ROBINSON TRACT RESIDENTIAL DEVELOPMENT STREET ROAD (S.R. 0926) AND NEW STREET CHESTER COUNTY WESTTOWN & THORNBURY TOWNSHIPS

May 15, 2020

RE: Robinson Tract Residential Development Westtown Township, Chester County, PA McMahon Project No. 816451.11

McMahon Associates, Inc. is in receipt of the Township's comment letter, prepared by Albert Federico Consulting, LLC in their capacity as the Township traffic engineer, dated March 13, 2020, in regards to the Transportation Impact Study for the Robinson Tract, prepared by our office and last revised December 2, 2019. It is noted that the applicant was not sent a copy of this letter for review. The development is proposed to be located on the Crebilly Farm property along the west side of U.S. Route 202 (Wilmington Pike), between West Pleasant Grove Road and Street Road (S.R. 0926), in Westtown Township, Chester County, Pennsylvania. On behalf of the applicant, below is a summary of the comments in italics, with our responses following each comment.

CHESTER COUNTY

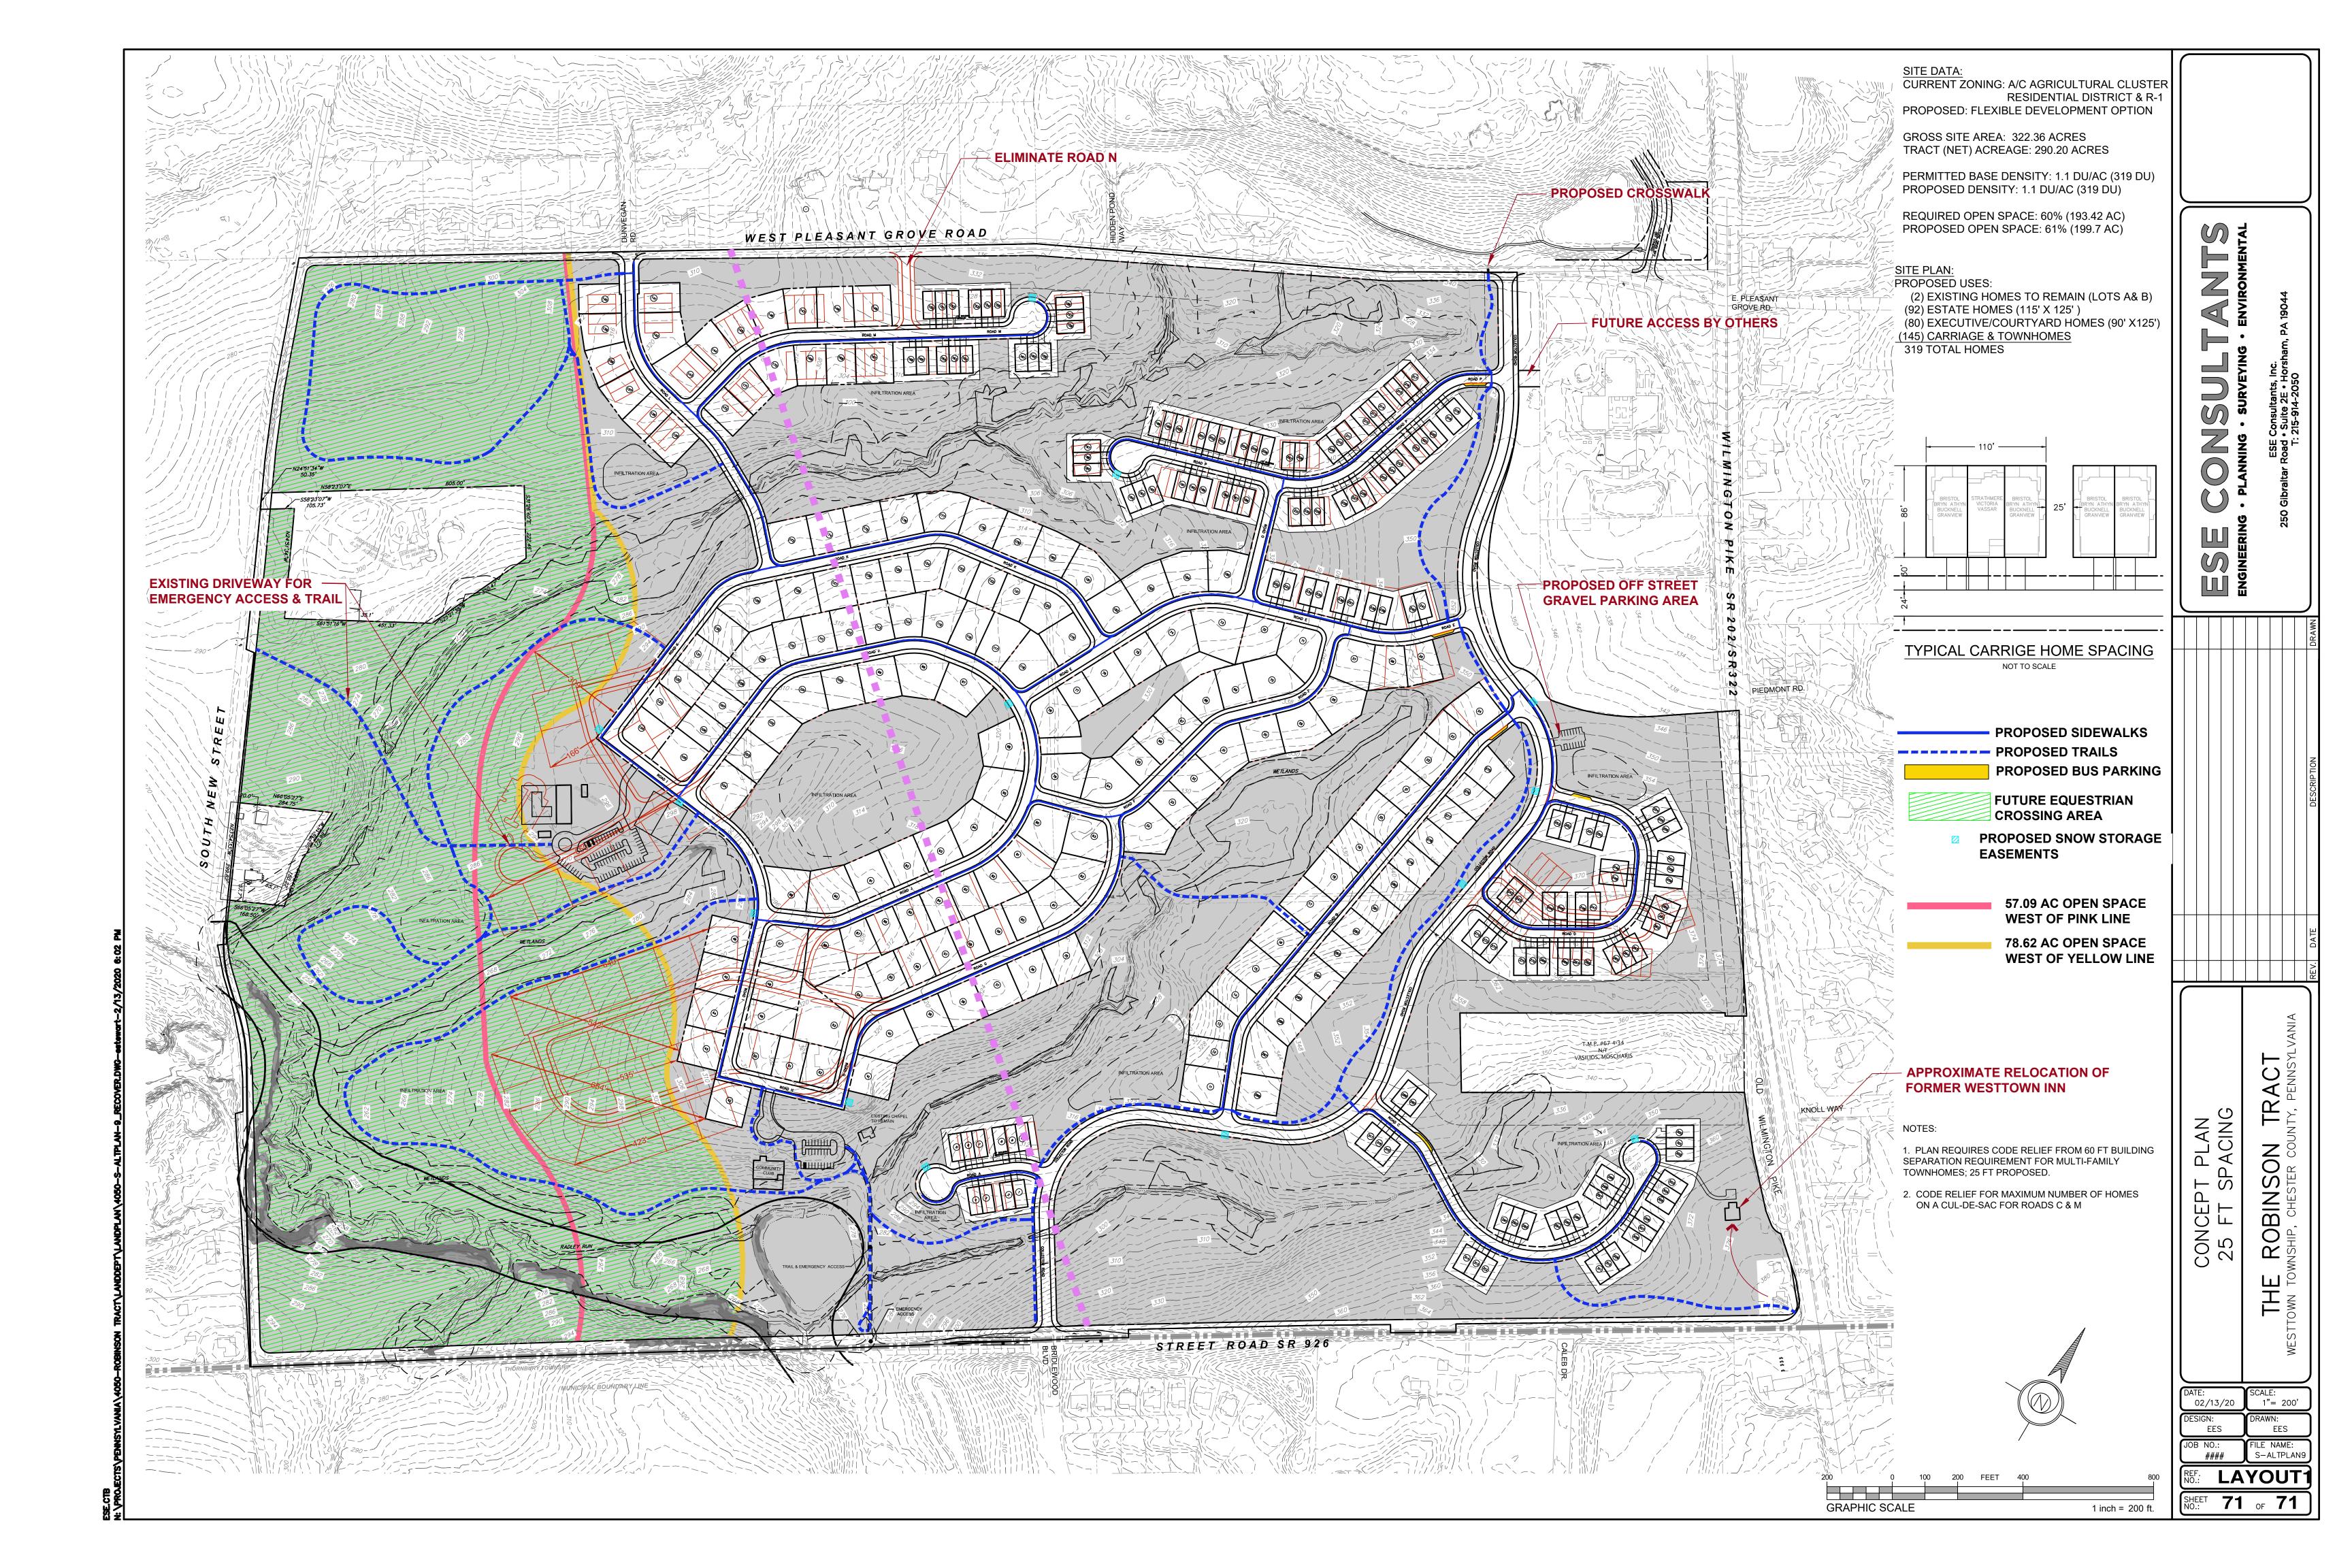
Additional grading and/or traffic management measures appear warranted to enhance safety at the three accesses proposed to have insufficient sight distance or the exact minimum distance (with no margin for error):

- (1) Collector Road at PA Route 926 (grading)
- (2) Road M at West Pleasant Grove Road (grading and/or roundabout)
- (3) Collector Road at West Pleasant Grove Road (grading and/or roundabout)

As documented on page 11 of the transportation impact study, dated revised May 15, 2020, the existing available sight distances at the site accesses meet or exceed the Township and PennDOT requirements. For the intersection of West Pleasant Grove Road and the Connector Road, the transportation impact study demonstrates that this intersection satisfies industry standard PennDOT traffic operations criteria and safety with stop-control on Collector Road approach. Aesthetics are not required by code. However, the applicant offers to install a mini roundabout at the Collector Road/West Pleasant Grove Road intersection, provided the Township acquires any necessary right-of-way to install. Traffic analysis worksheets for a mini roundabout at this location are attached.
